Nebraska Public Power District
Nebraska's Energy Leader

NLS2001051
May 16, 2001

Subject: Additional Information Related to Potential Yellow Finding (EA 00-248)
NRC Inspection Report No. 50-298/00-07
Cooper Nuclear Station, NRC Docket 50-298, DPR-46

3. Letter to J. H. Swailes (NPPD) from C. S. Marschall (NRC) dated April 16, 2001, "Cooper Nuclear Station - Request for Additional Information Regarding a Potential Yellow Finding (EA 00-248)."

Figure 1

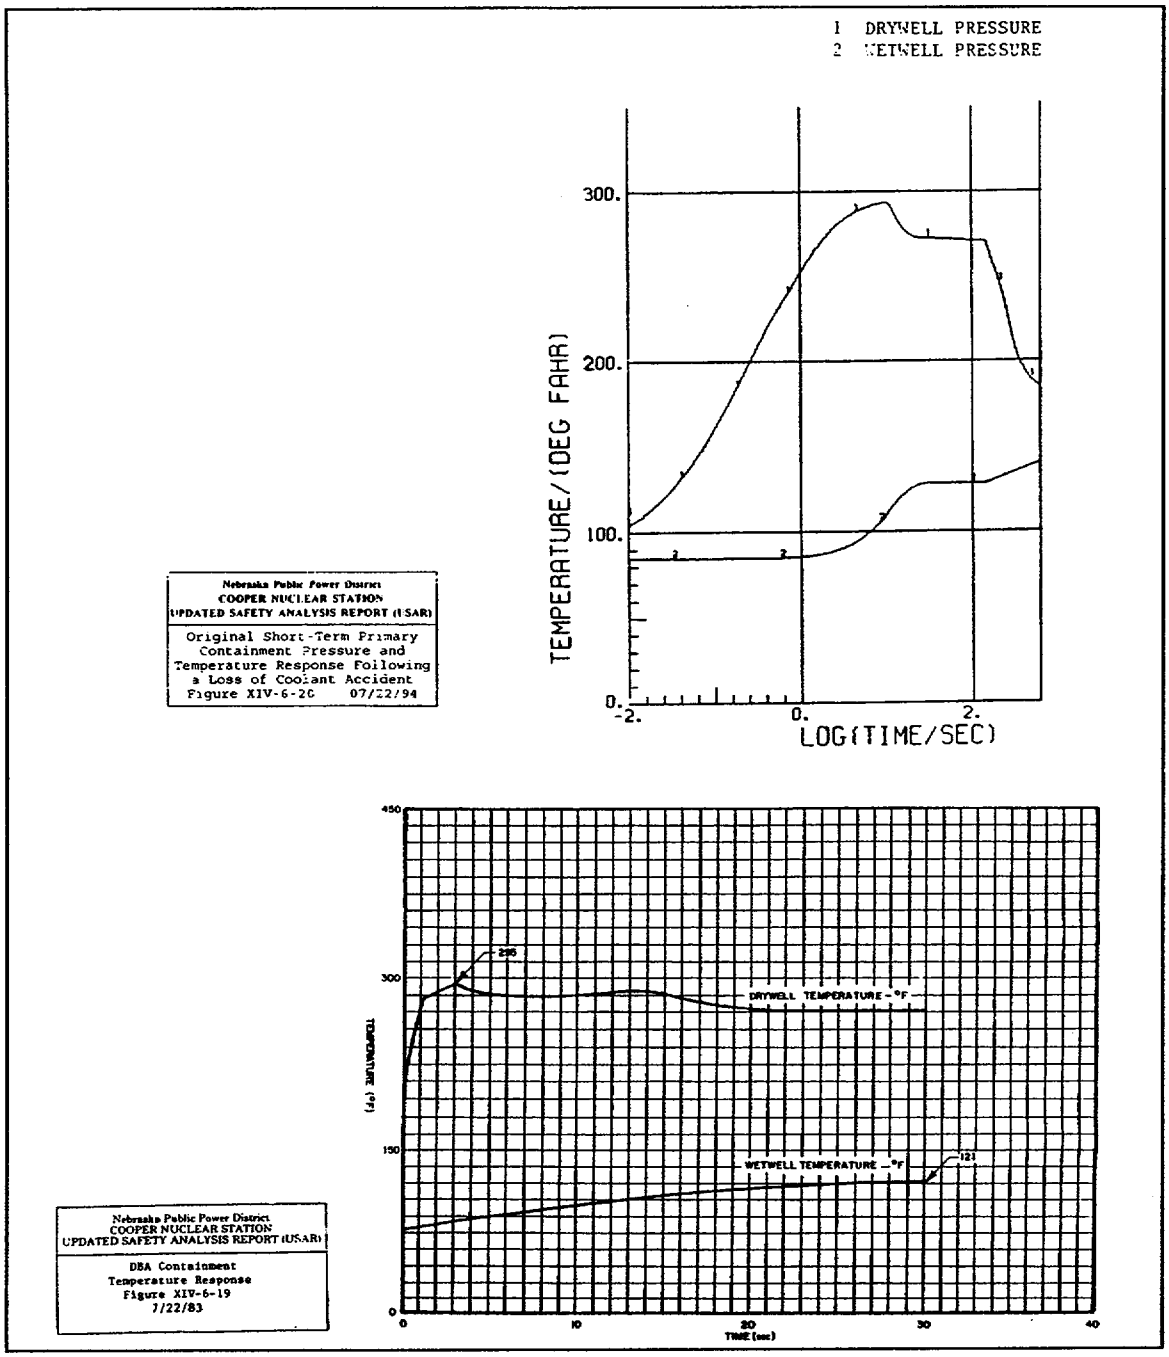
1b. Identify the margin provided with regard to the temperature profile used in the operability evaluation (OE) (i.e., 340F vs. the test report 355F).

The testing to qualify the SRV solenoid valves was designed by TRC to qualify the valves to generic boiling water reactor (BWR) conditions including a peak temperature of 340F. The testing utilized the recommended temperature margin specified in IEEE 323-74 and Regulatory Guide (RG) 1.89, but no additional margin exists at the peak temperature. However, when compared to the CNS specific profile there is significant duration margin at the peak conditions. There is also significant temperature margin throughout the entire profile.

The design basis accident (DBA) composite profile in EQDP-46 reflects a maximum dwell of approximately 33 minutes at 340F. The tested temperature profile contains additional margin in that it exposed the test specimens to 355F for approximately three hours. This is significantly longer than the required profile for the small steam line break (SSLB). The time equipment is required or demonstrated to remain functional is the most significant in terms of additional confidence in qualification that is achieved by adding margin to service conditions. EQDP-253 establishes qualification of the SRV solenoid valves for the maximum 6-month post accident operating time period.

Figure 3

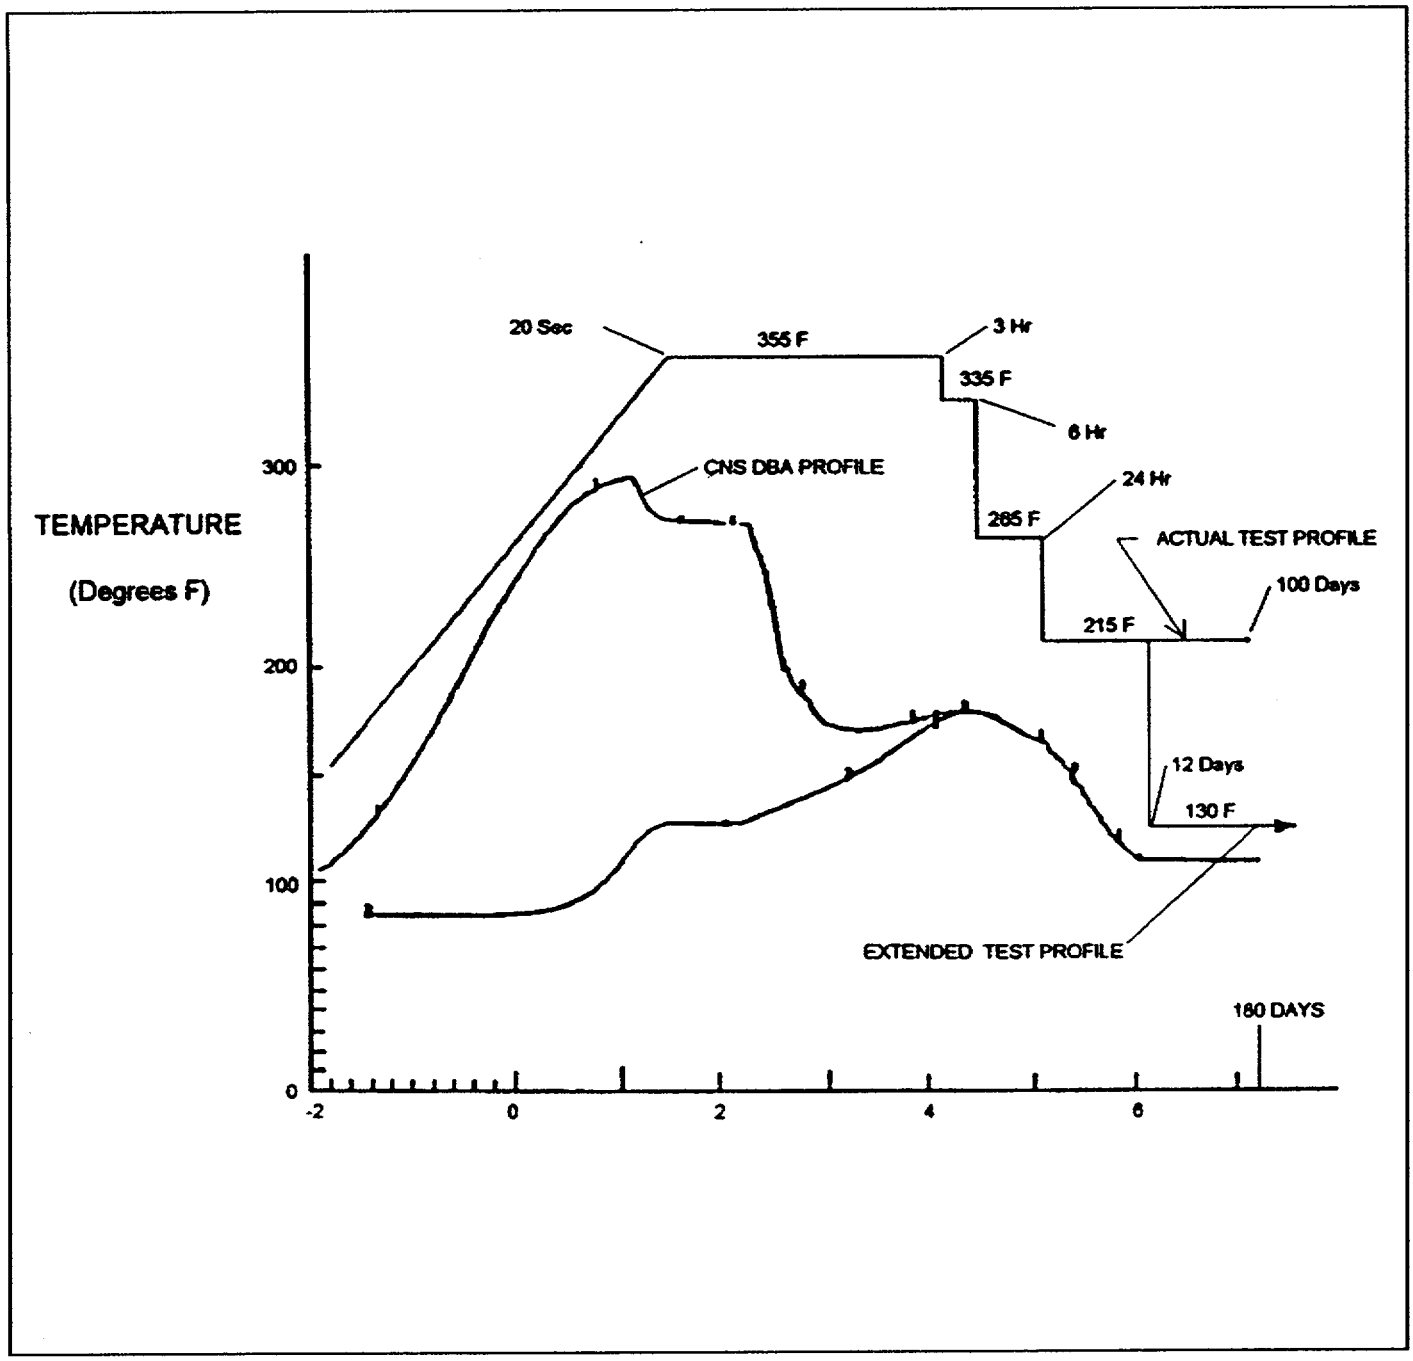
1c. Confirm qualification included the IEEE-323 required testing to a double peak (include resolution of problem identification report (PIR) on this topic).

Enclosure A provides the test report profile information which shows a double peak test was conducted. The test report used to establish qualification of this equipment (EQDI 2580) did expose the test specimens to two temperature transients which both had a 15F margin over the required peak temperature of 340F. Therefore, the testing in EQDI 2580 satisfies the recommended temperature margin in IEEE 323-74 and RG 1.89.
